## SWR Sound Corp.

### LA12 & LA15 - Power Amp Board

November 2000      Revision A      Page 1 of 1

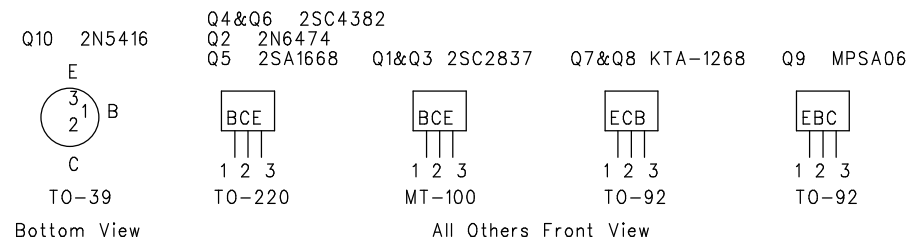
Changes apply to both the LA12 and LA15 assemblies
